I would like to bring attention to a certain area of the inland rail route.

Figure 2

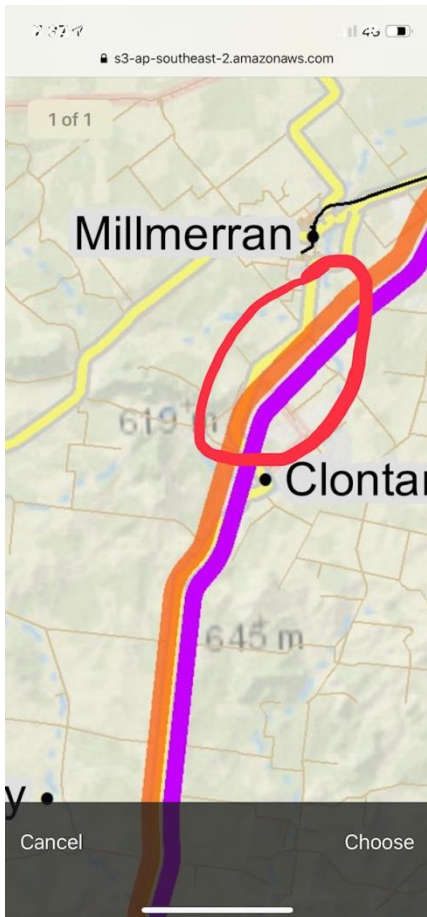
The route was always of the southern side of our local Millmerran-Inglewood road, just south of Millmerran. The maps provided showing where it was to be located near our area during all the public information sessions and mail correspondence as shown in figure 1. Therefore because the 2km study area never crossed my boundary, we did not receive any letters. A year later, we received a letter advising our place was affected and are welcome to come to the information sessions. I then made contact to the ARTC via phone speaking with Laura, asking if something had moved of which I was assured that nothing had moved. While looking at an interactive map online, I noticed that it had moved alignment (see figure 2). I then made contacted with Laura again from the ARTC and was once again assured that nothing had moved and told numerous times that 'We can-not move the 2km wide study area'.

Figure 3

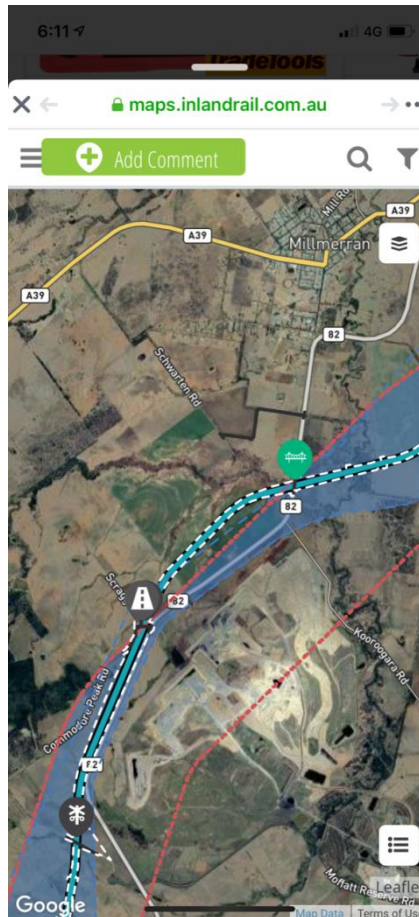
My wife & I then had a meeting in person with Laura & Robert McNamara from the ARTC of which we showed them copies of the maps showing that the corridor had moved (Figure 3 & 4). They then admitted they moved it at the request of the Millmerran Power Station (Intergen).

In moving the alignment from one side of the road to the other, it crosses 3 extra local roads, impacts 3 more houses, impacts the town substation and requires the realignment of about 4 local power lines whist also moving the rail line closer to Millmerran Township. Not to add that it would add millions of dollars to the cost of building it.
